Committee Date	5 th October 2023	
Address	UNIT 2A FARNBOROUGH WAY (Frankie & Benny's) FARNBOROUGH ORPINGTON BR6 7DH	
Application number	23/00848/FULL1	Officer Agnieszka Nowak-John
Ward	Farnborough and Crofton	
Proposal (Summary)	Demolition of the existing buildings on the site and the construction of a foodstore (Use Class E), alongside the provision of a surface level car park, associated access and landscaping works.	
Applicant	Agent	
ALDI Stores Ltd.	Miss Katia Clarke Planning Potential Ltd.	
Reason for referral to committee	Strategic/Major Development	Councillor call in Yes (Due to local interest)

RECOMMENDATION	Refuse Planning Permission
KEY DESIGNATIONS	
<ul style="list-style-type: none"> • Biggin Hill Safeguarding Area • London City Airport Safeguarding • Smoke Control

Fig.7.4 Southern Elevation - previously refused scheme (top) and revised (bottom).

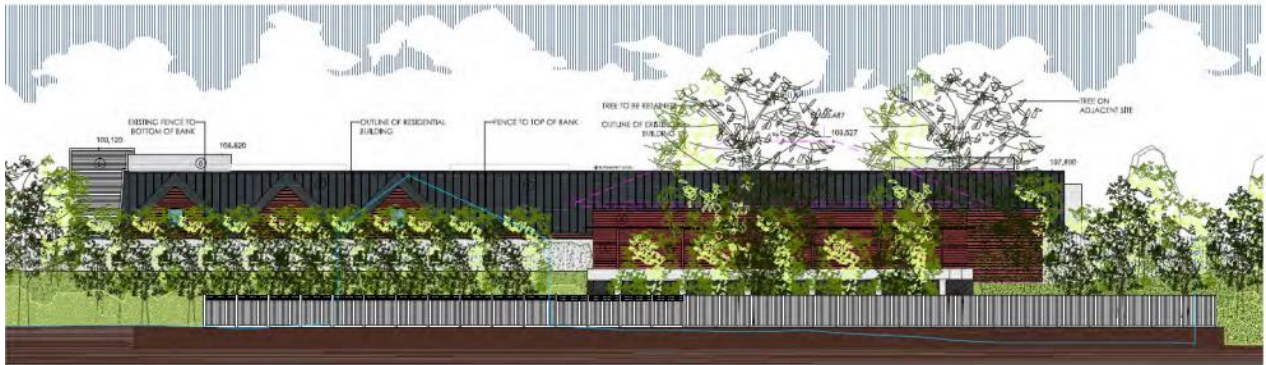
- 7.4.4 In officers' view the proximity and elevated position of the proposed retail unit remain a concern. However, the revisions to the scheme are acknowledged and these have significantly improved the relationship with the residential properties to the south. Reducing the building footprint provided further separation which allows for an improved landscape planting scheme along the southern boundary (which includes the retention of existing mature trees and shrubs).

- 7.4.5 Therefore, on balance, the resulting amenity impacts are not considered to be adverse enough to justify the refusal of a planning consent. To this end, officers are satisfied that the second reason for refusal has been satisfactorily addressed (Fig. 7.1 to Fig 7.4).

Fig 7.5 Map of public transport accessibility level (PTAL) of the site.

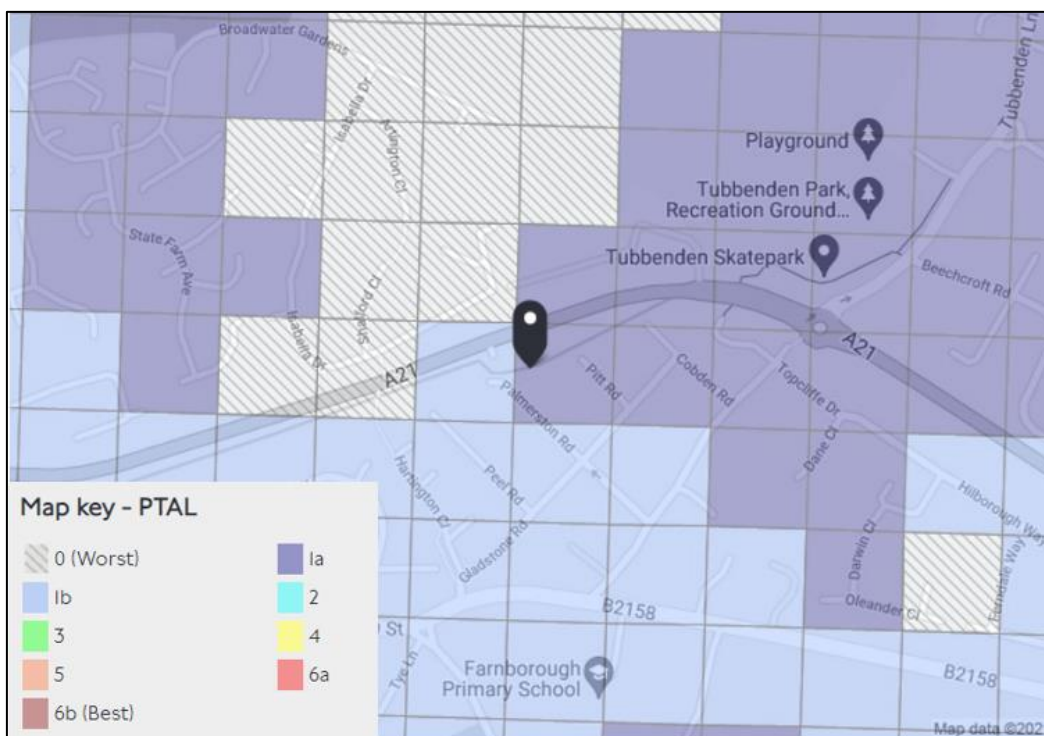
7.5.6 In the Transport Assessment (TA) the applicants state that "PTAL values are based on the frequency of services during the morning weekday peak". The TA argues that while useful in indicating the overall level of service, this is not a period typically associated with undertaking food shopping. In this regard, PTAL is not tailored for specific uses, but rather provides an indication of overall accessibility. As such, TfL's document goes on to note that some caution should be applied when using PTAL, stating it is "important to use professional judgement when analysing PTAL outputs and to interpret any result in the relevant context".

7.5.7 This comment is noted. Officers agree that the PTAL model does not appear to include the footpath alongside Hartington Close which provides access to the nearest bus stops served by the 345 bus route. Consequently, a manual calculation may provide a marginally higher PTAL, although the distance from

the stops would limit the potential improvement. In this instance, however, it is considered that the PTAL score would provide a representative overall indication on how accessible the site is, compared to the rest of the borough. In this case, it is clear that the site is not easily accessible by public transport.

Fig 7.6 - Footway/ cycleway widening to the part north of the application site

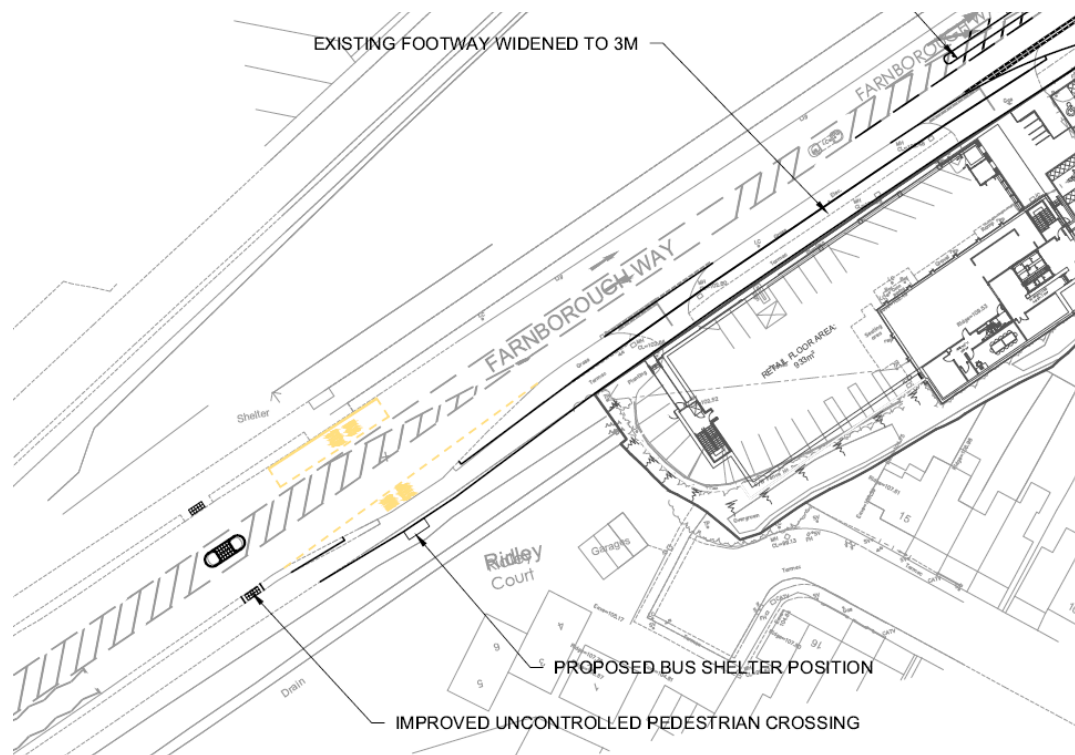
7.5.21 The proposed improvements are considered acceptable. The highway works would be subject to S278 agreement and a financial contribution would be payable by the developer to TfL in order to move the bus stop.

Fig 7.8: Proposed all-movement give-way junction (Option 1)

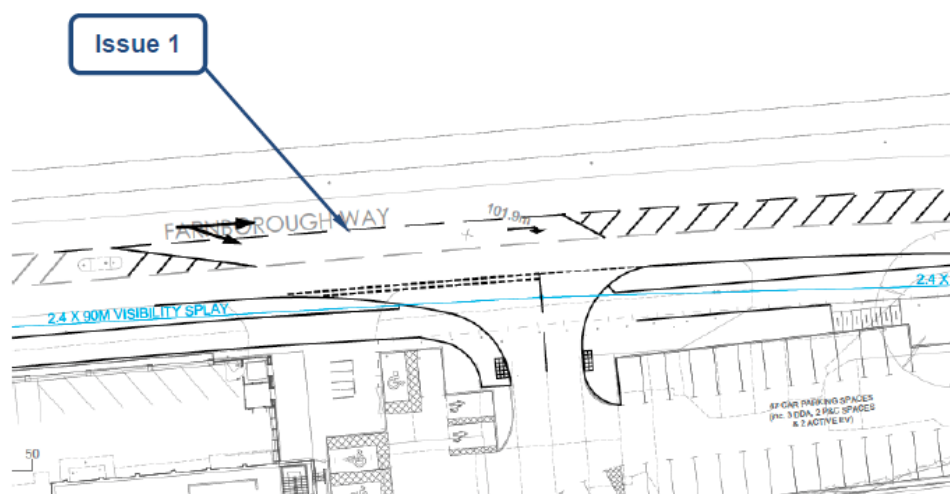
7.5.40 The Road Safety Audit shows that the access/ egress point without a centre refuge (Option 1) would be the optimal option. The proposed width of the access, at the narrowest point, would be some 7.8m wide. The audit report identifies that the proposed right turn lane on the A21 has sufficient capacity to accommodate 4 vehicles seeking to undertake the right turn. Whilst the report has identified an issue that during busy times this right turn lane may cause queues to develop back onto the A21, it identifies that forward visibility of any queue for approaching drivers is excellent and any queue is therefore unlikely to result in collisions. The report further suggested that it could be beneficial to relocate the existing refuge island (on the A21) to allow for the right turn lane to be extended (Fig. 7.8).

7.5.41 The transport assessment has demonstrated that during peak hours there would be no car queuing on the A21. However, the modelling shows that during PM peak hours (14:15 to 17:15) and Saturday (12:45 – 13:45) a potential 2.4 cars would be queuing within the application site waiting for the right turn onto the A21 with a waiting time of 150 seconds during the busiest 15-minute time segment as shown in the model. (Table 7.4)

Fig 7.9 – TfL’s preferred option (junction with central refuge)

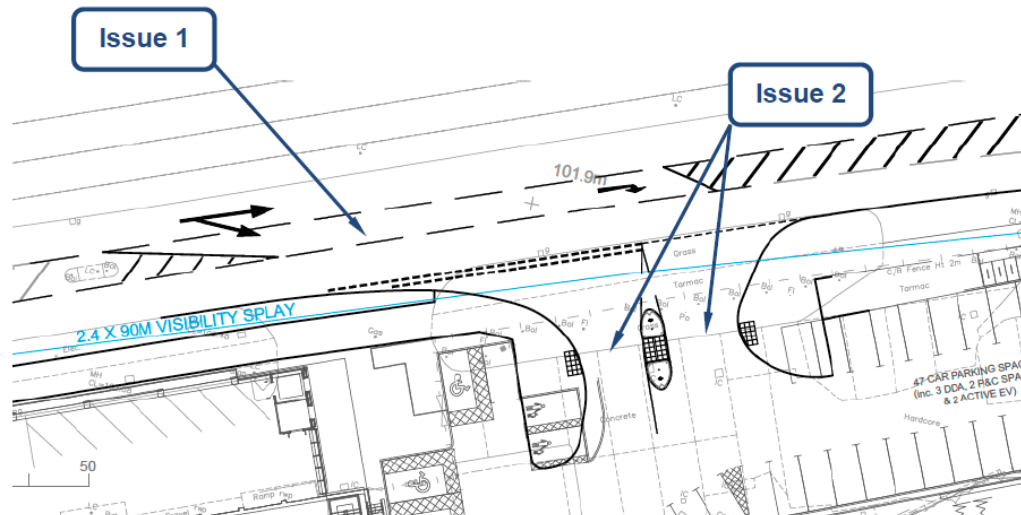
7.5.42 TfL has reviewed these three site access options and commented that their preferred junction access option would be option 2 – a single access entrance/ egress point with a pedestrian/ cyclist refuge located in the middle (Fig 7.9). This arrangement could potentially improve the comfort of pedestrian and cyclists crossing. However, this option would have impacts on the application layout design and some parking spaces could need to be removed to accommodate it. The applicant has therefore opted to progress with option 1 – all-movement junction (Fig 7.8).

Fig: 7.10 Proposed Staff cycle parking

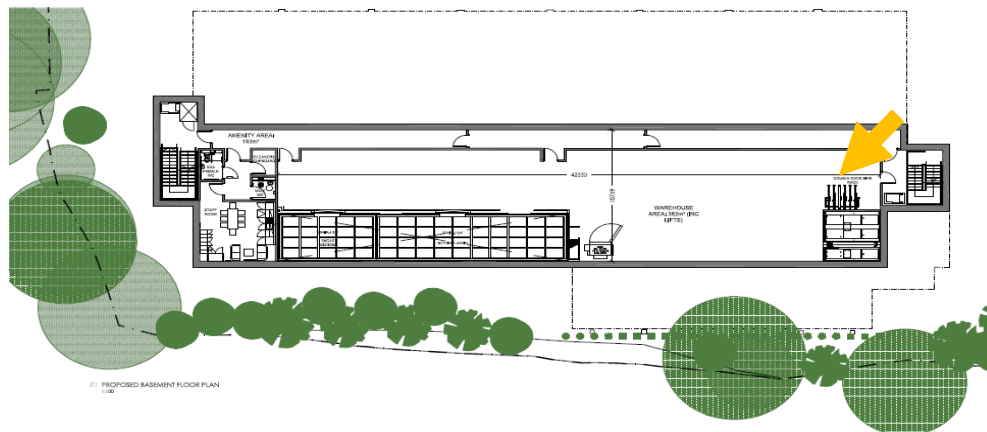
7.5.61 TfL remains concerned about the 2-tier rack proposal as this parking arrangement would require the cycle to be lifted. This would exclude a large proportion of staff who should otherwise be able to cycle and whose particular characteristics would be protected under the Equality Act, e.g. pregnant, disabled and older people. TfL consider that Sheffield stands should be provided instead. However, the applicants view is that the lower tier is the equivalent of Sheffield hoops with the higher stands for those who are able to lift their bikes onto the stands. Also, Sheffield stands would be provided within the warehouse for staff use.

7.5.62 In a recent supporting letter dated 21.09.23, the applicant has said that “*For any staff who are less abled and who cycle to work, a secure accessible storeroom is available at the ground floor level within the amenity block and does not need to be accessed via a lift.*” However, to date, officers still have not received any revised drawings to show these changes. It is also noted that the only available lift is designated for moving of goods. Nevertheless, this change can be secured by a condition should permission be granted.

Fig 7.11: Proposed visitor cycle parking

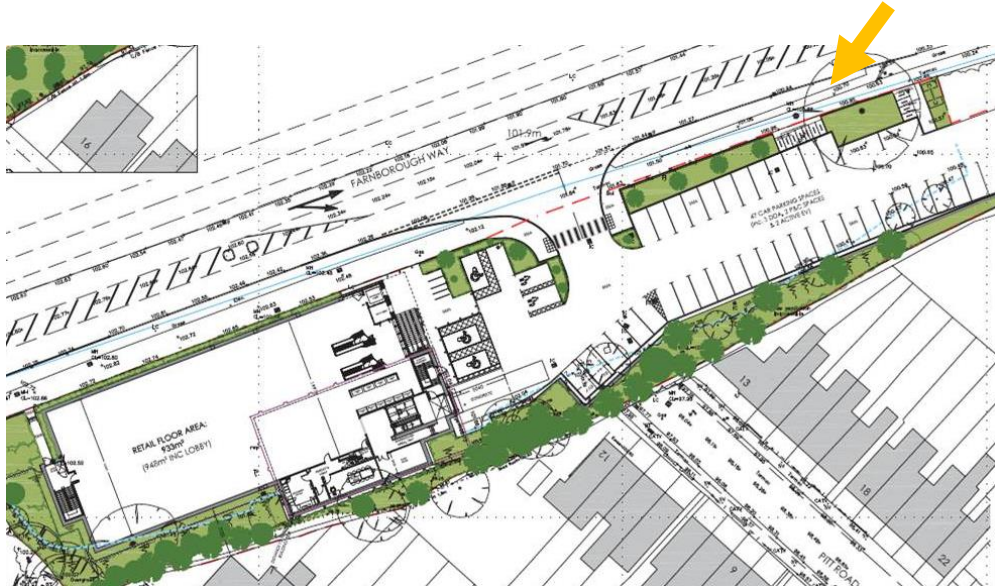
7.5.63 A total of 22 short stay cycle storage spaces would be provided for customers within the car park. This provision is acceptable and compliant with London Plan Policy T5. The proposed cycle parking would be located at the eastern end of the car park, facing the A21. This would be some 60m to 82m away from the food store entrance (Fig 11). TfL and Highways Officers have been consulted and object to the location of the cycle parking as it should be located close to the store entrance/exit for convenience and maximum natural surveillance (Fig 12 - area in red). Also, the bike parking area should accommodate non-

conventional cycle parking spaces (e.g. tricycle) for people who are disabled to comply with Policy T5 (B) of London Plan.

7.5.64 It is further advised by TfL that the proposal should provide Sheffield stands at 1.2m spacing (for two cycles, i.e. 0.6m each), and at least 5% of spaces should be wide enough to accommodate a wider cycle (0.9m minimum per cycle).
